Field Modification Form Lower Passaic River Restoration Project Remedial Investigation Project No: 60145884

Field Modification Number: FM-130522-1

**Document (plan or SOP title and date)** Quality Assurance Project Plan. Low Resolution Coring Supplemental Sampling Program. Lower Passaic River Restoration Project. June 2012, Revision 3

FIGURE 1

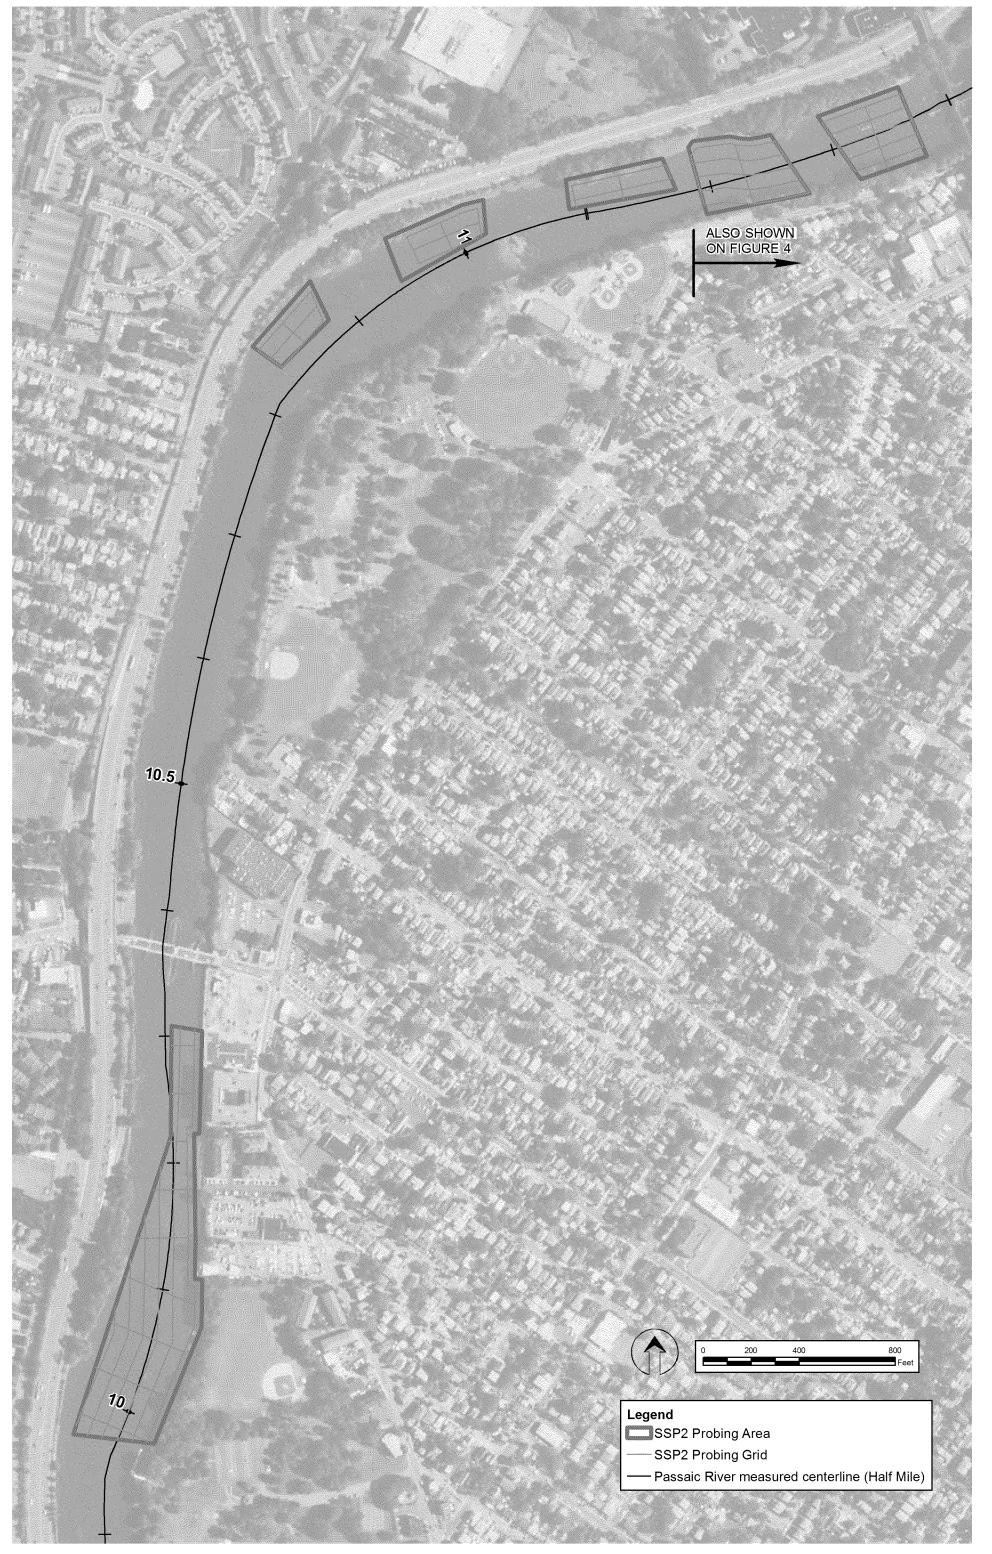
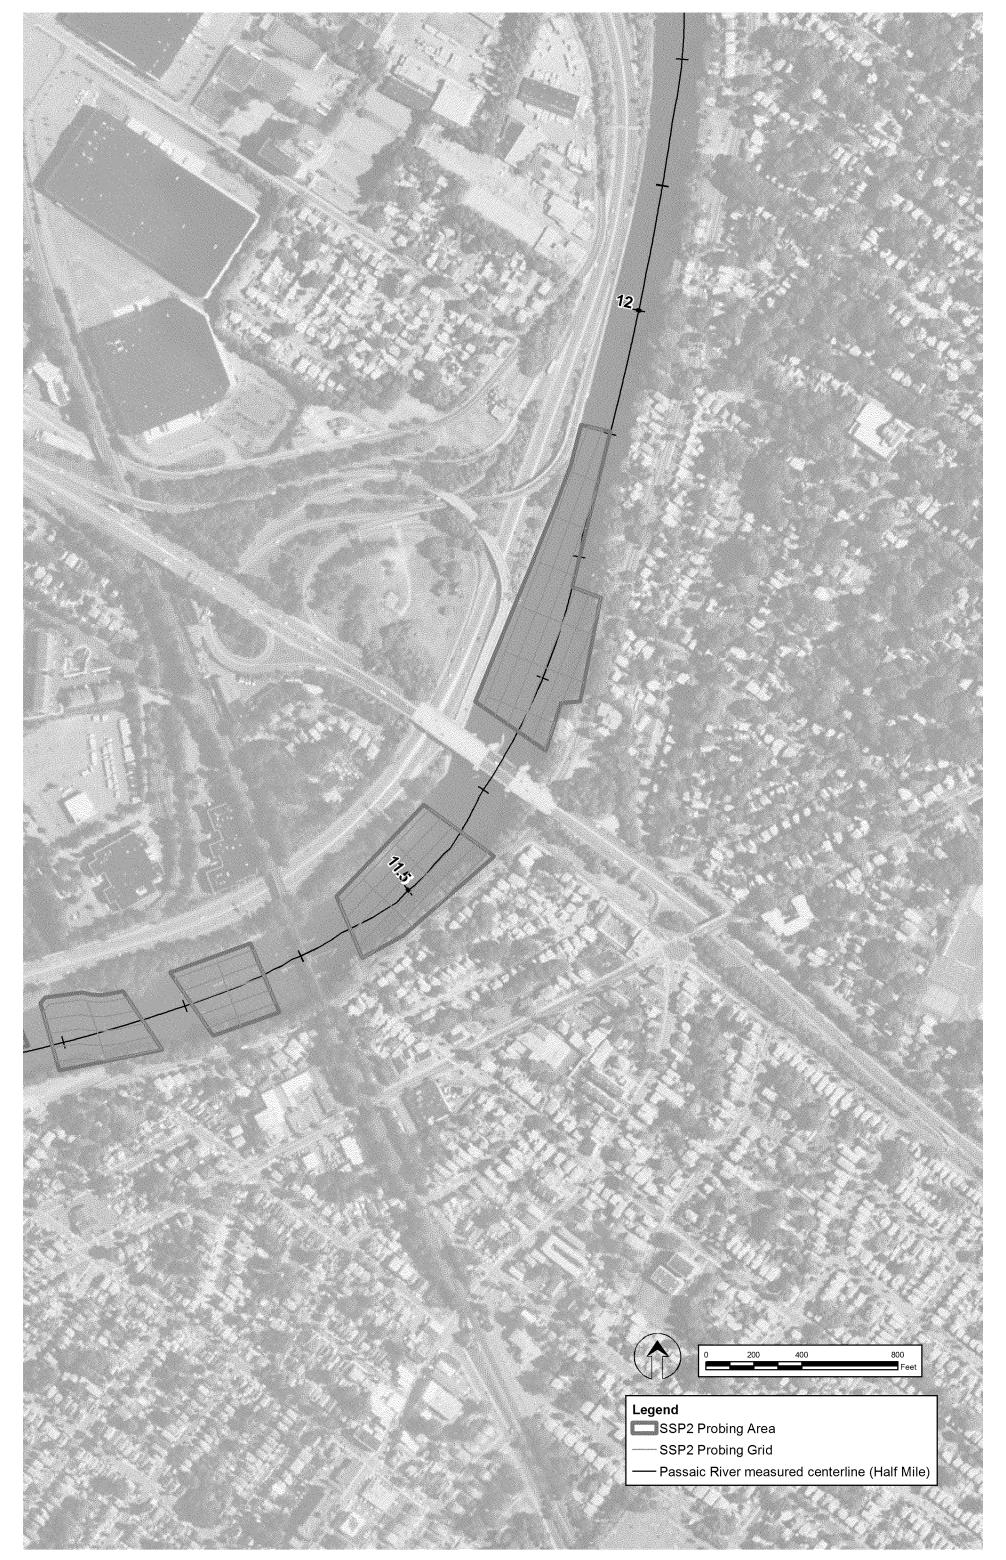
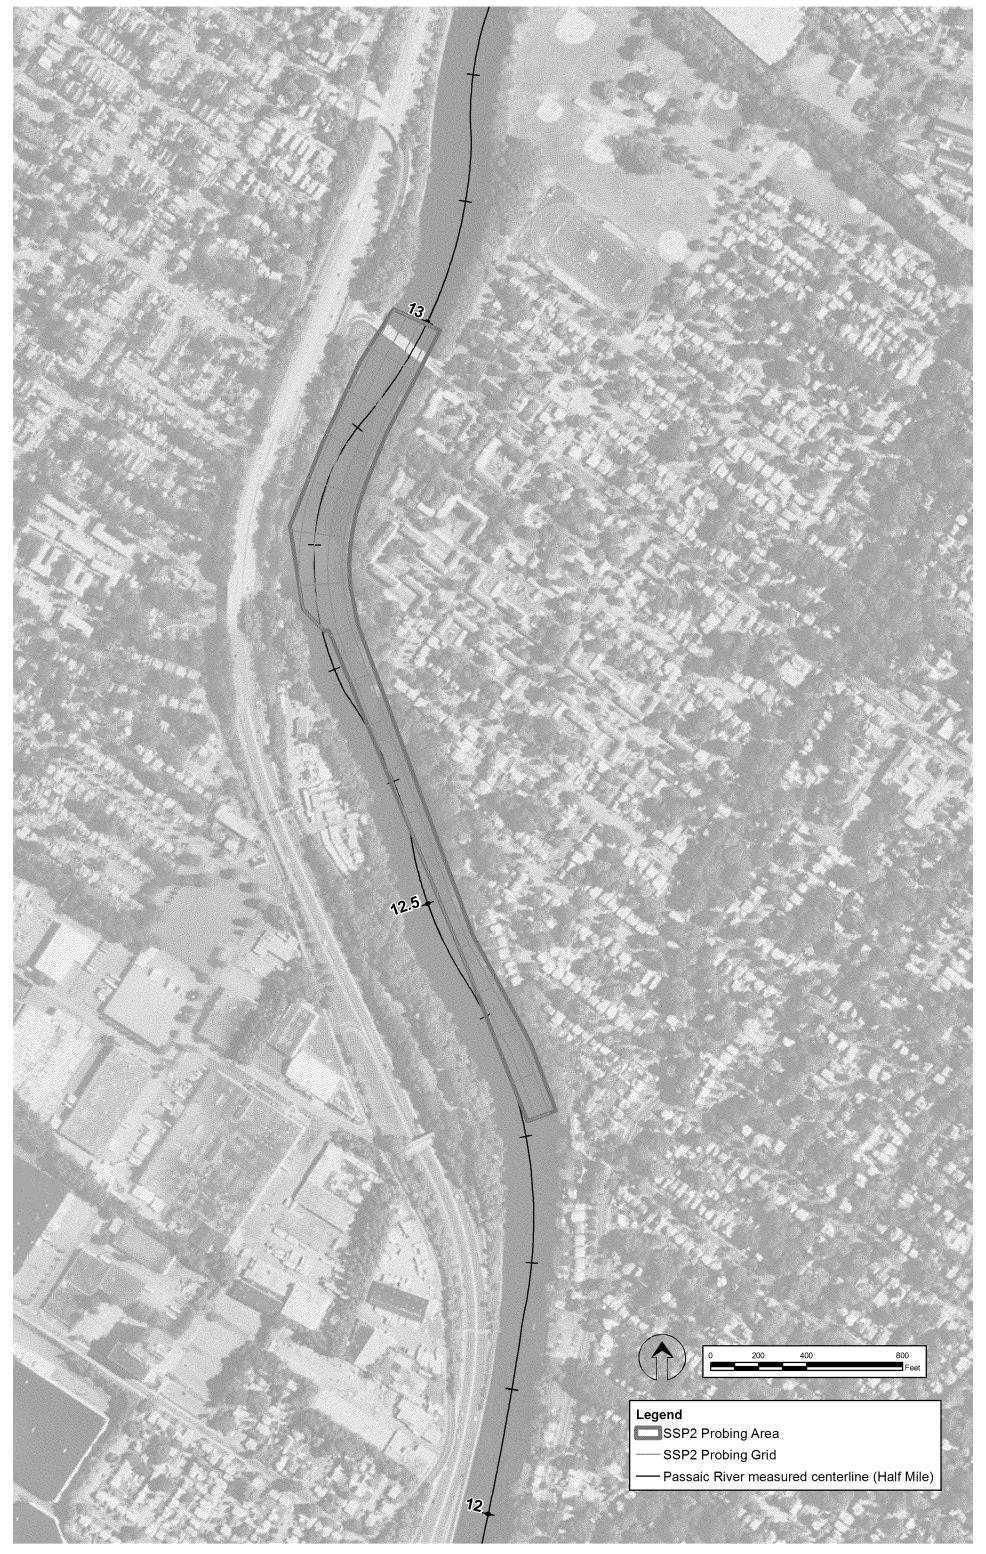
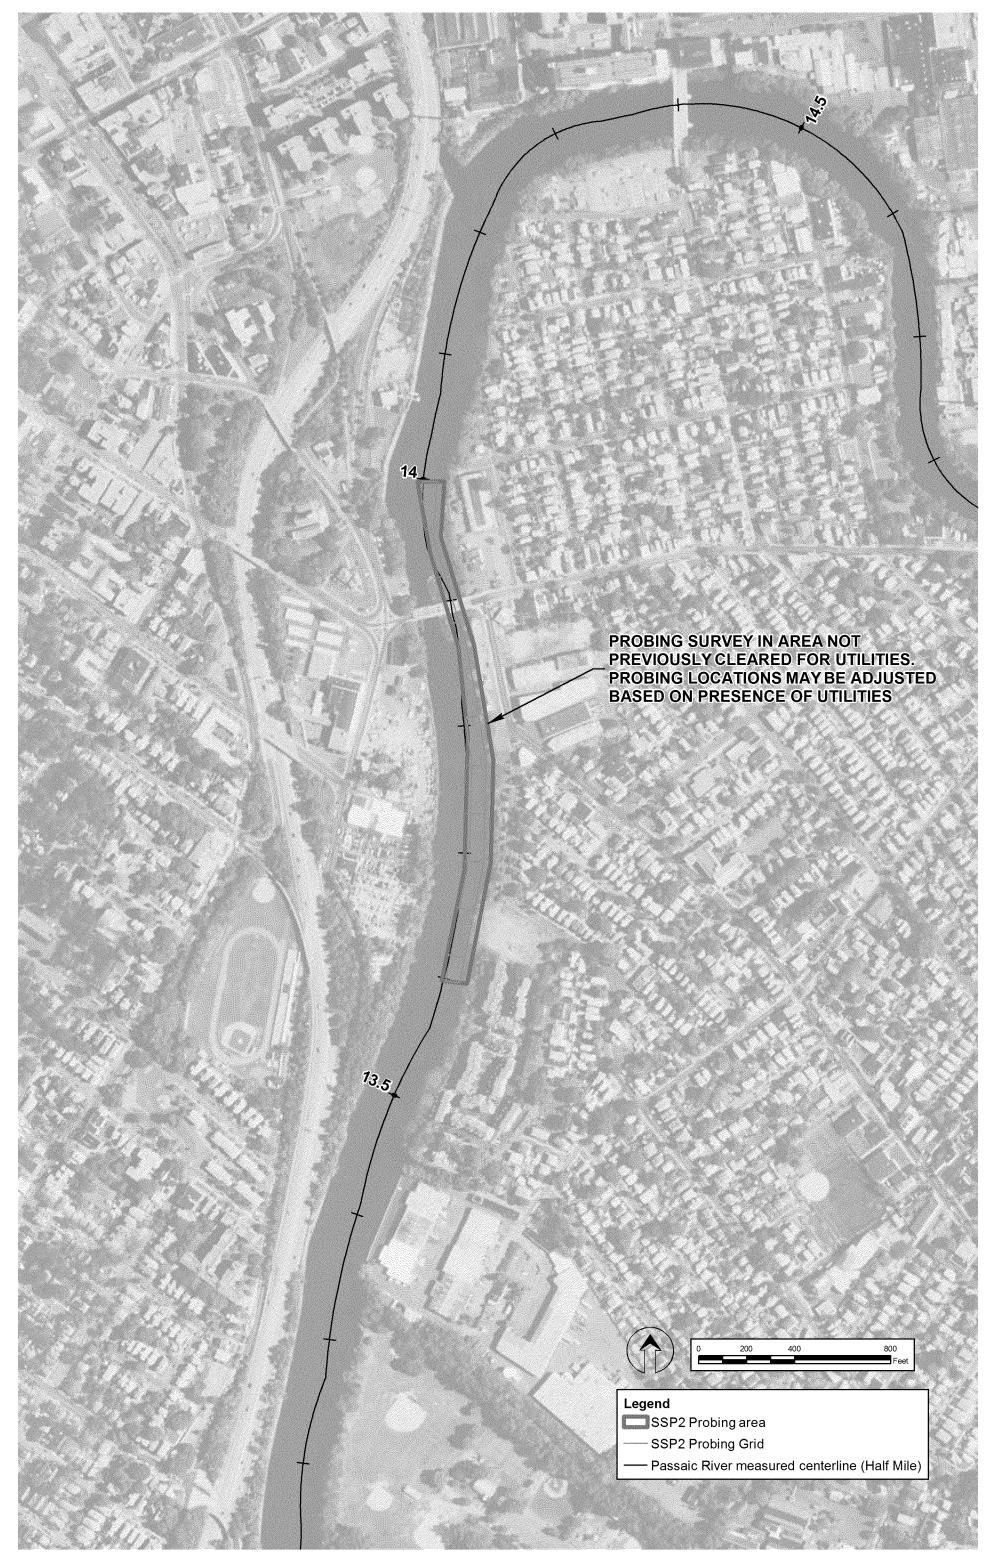
Probing will generally be conducted within each area along an approximate grid pattern established at 200 foot spacing perpendicular to the river bank and 60 foot spacing parallel to the river bank. The approximate location of the grid pattern for all the areas is shown on Figures 2 through 6. Adjustments to these grid patterns may be made in the field to accommodate site conditions. Such changes will be discussed in the field with the USEPA oversight contractor and communicated to the CPG and USEPA at the end of each field day. Additionally, detailed utility surveys have not been performed in one of the proposed probing areas, the area between RM 13.6 and RM 14.0 shown on Figure 6. A portion of this area is identified in the National Oceanic and Atmospheric Administration (NOAA) navigational charts as having cable and pipelines. As part of the utility notification for all areas prior to conducting the probing survey, a detailed inquiry into the presence and nature of utilities will be conducted of this area.
